Re 156-165 Lowland Street NOI

STORMWATER REPORT

157-165 Lowland Street
Holliston, MA

**Re: Site Plan, Zoning, & Stormwater Design Engineering Peer Review #3
Master Paving Corp. & Middlesex Asphalt Services, Inc.
157 - 165 Lowland Street Holliston, MA
CMG ID 2022-154**

Table 1. Stormceptor Models

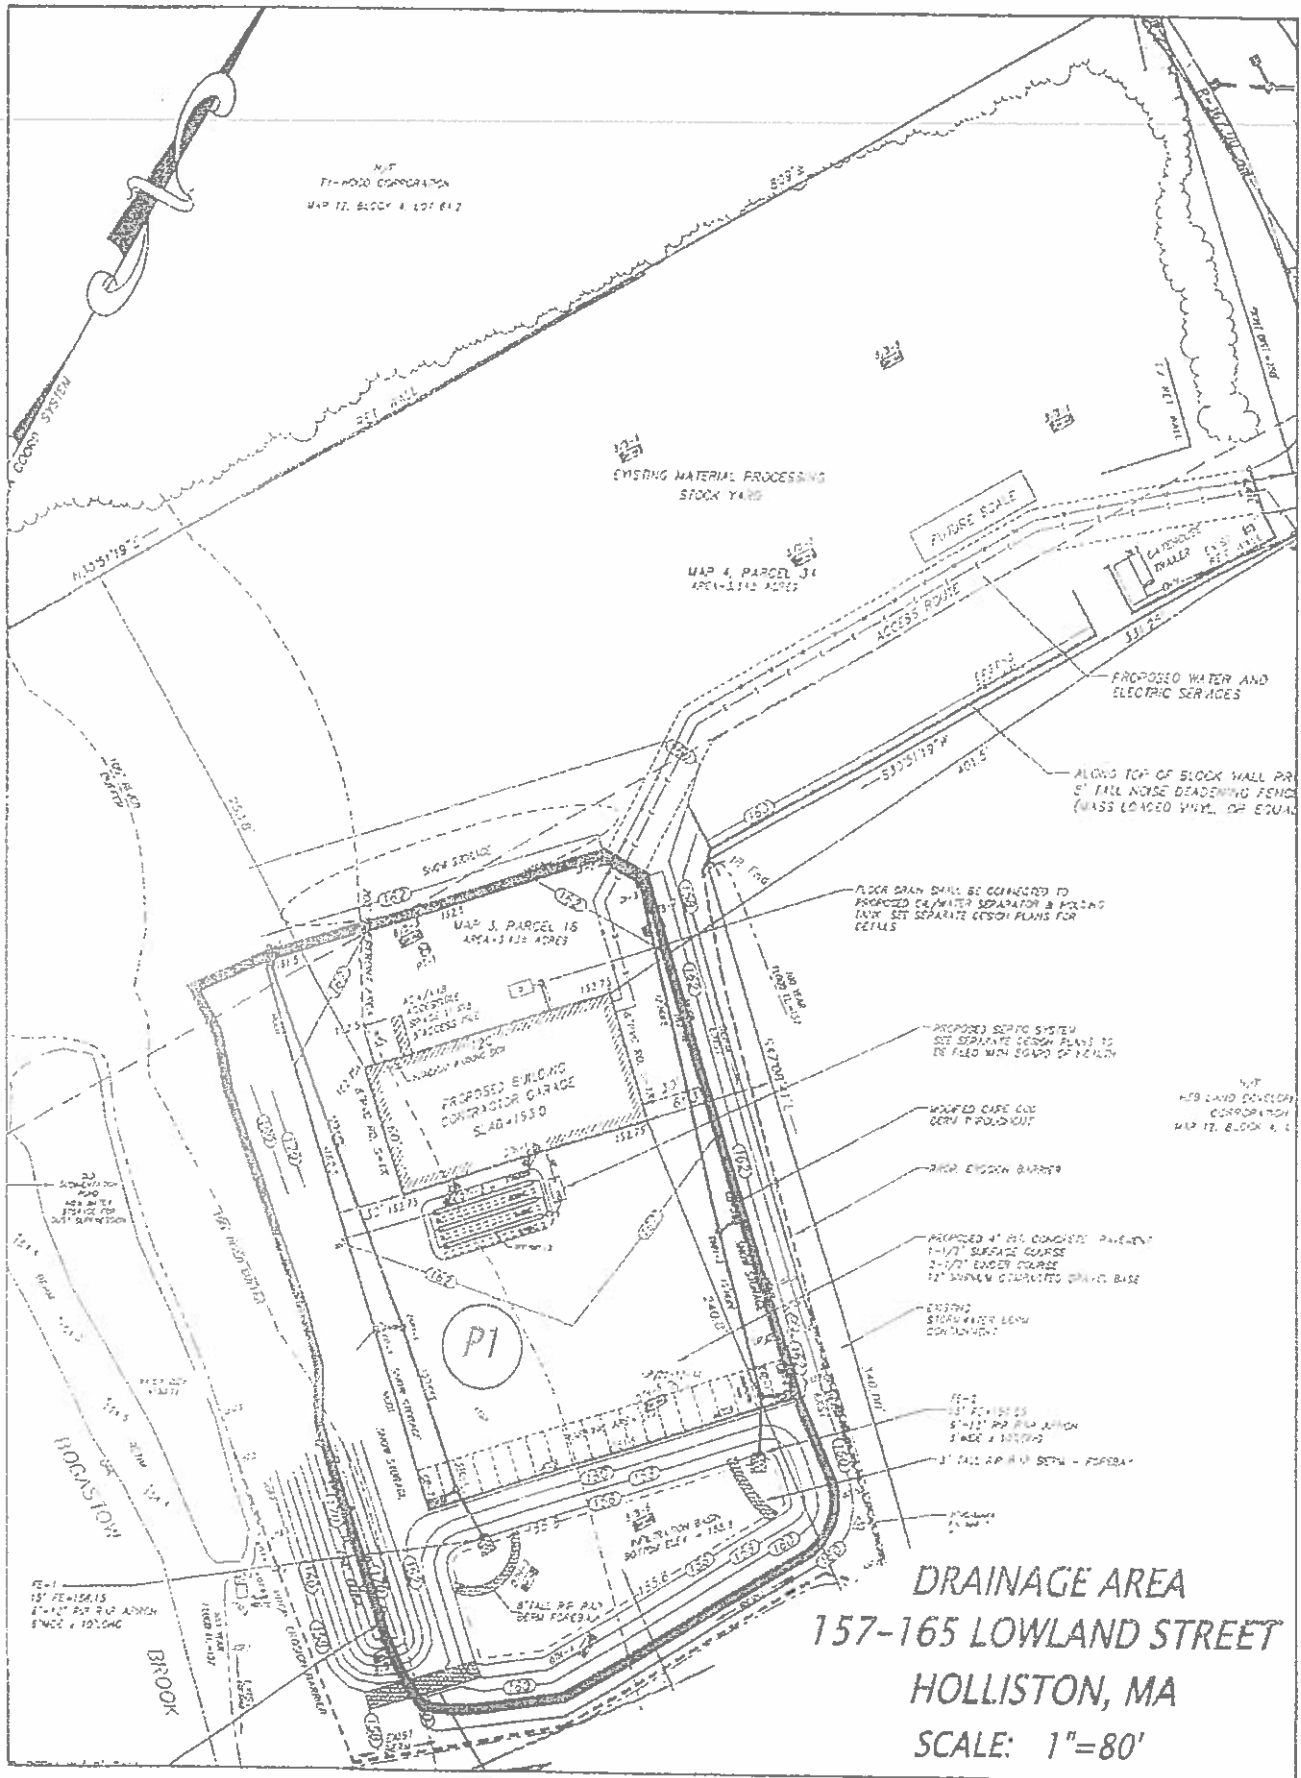
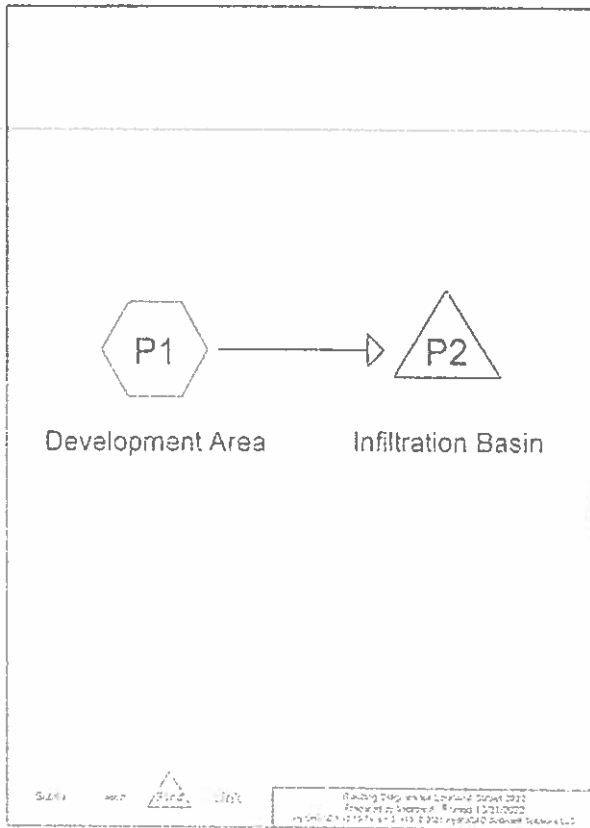
CMG Comment #2: MassDEP Stormwater Management Standard 5 requires the use of an oil / grit separator be included in the treatment train designed to treat the water quality volume (i.e. 1 inch of runoff). Proprietary treatment BMPS may not be used as a terminal treatment device for a LUHPPL.

CMG Comment #3: CMG is in agreement the chosen proprietary separator, Stormceptor Model 900, is appropriate for use as pre-treatment as proposed for this project. CMG recommends "monthly" inspections of the STC 900 water quality units and cleaning twice / year or when the sediment depth is greater than 8 inches.

Connorstone Response (11/23/22): The review comment had requested the use of an oil/grit separator as pretreatment prior to infiltration. MassDEP Stormwater Handbook, Volume 1, Standard 5 requires pretreatment for fleet storage to include "an oil grit separator, a sand filter, organic filter, filtering bioretention area, or equivalent. The table of recommended BMP's under this standard also includes Proprietary Separators as an acceptable form of pretreatment.

The proposed plans have proposed an equivalent to an oil/grit separator with a proprietary separator. The proposed separator is designed to remove both oils and sediment (grit). The proposed separator provides double wall oil containment with a continuous fiberglass insert to ensure any hazardous floatable do not migrate through the concrete walls. In order to provide enhanced level of treatment the sizing of the separator has been increased on the proposed plans to a STC 900.

Connorstone Response (1/04/23): Oil/Gas Containment – the applicant has confirmed the largest oil / gas storage tank on-site would be a 150 gallon gas tank on the largest piece of equipment. The proposed Stormceptors (model 900) have an oil/gas storage capacity of 251 gallons each. The product data to verify the storage is attached.
